NUMBER
231 (Rev 2, 08/24/2021)

TECHNICAL SERVICE BULLETIN

**FRONT VIEW CAMERA REPLACEMENT
FOR DTC C160449 & C160649**

Front View Camera

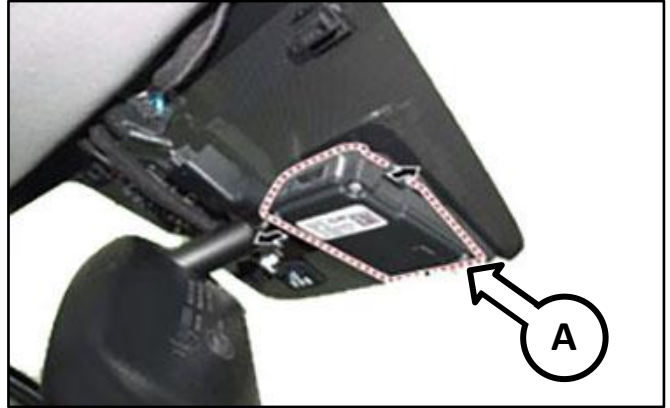
This bulletin provides information on the inspection and replacement of the front camera on some vehicles listed below. Due to an internal control chip concern inside the camera, the vehicle may exhibit a Forward Collision Avoidance Assist Warning Lamp (A) and/or Master Warning Lamp (B) with C160449 and/or C160649 codes. Certain systems may become temporarily disabled during occurrences: Smart Cruise Control (SCC), Lane Keep Assistance (LKA), Lane Departure Warning (LDW), Forward Collision-Avoidance Assist (FCA), Forward Collision Warning (FCW) and/or Driver Attention Warning (DAW). Follow the procedure outlined in this publication to diagnose and replace the front view camera assembly.

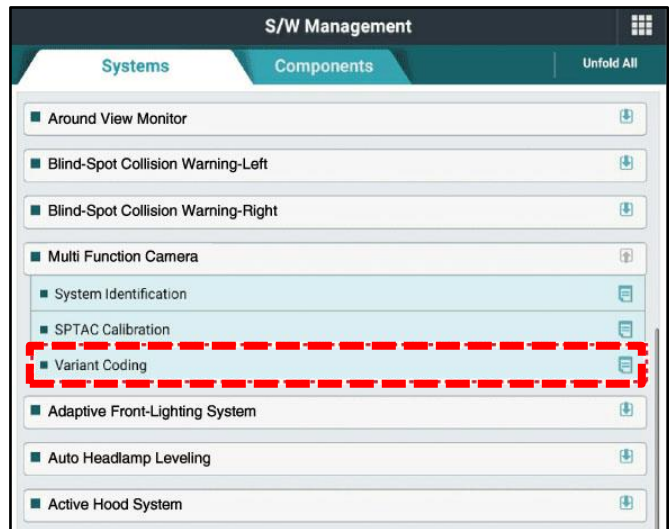
1. Remove and replace the Front View Camera (A) by referring to the “Body Electrical System → Front Camera System → Front View Camera Unit → Repair Procedures” chapter in the applicable Shop Manual on KGIS.

2. Perform the “Variant Coding” procedure by referring to the “Body Electrical System → Front Camera System → Repair Procedures” chapter in the applicable Shop Manual on KGIS.

After replacing the front camera with a new unit, the **Variant Coding** procedure **must** be performed.
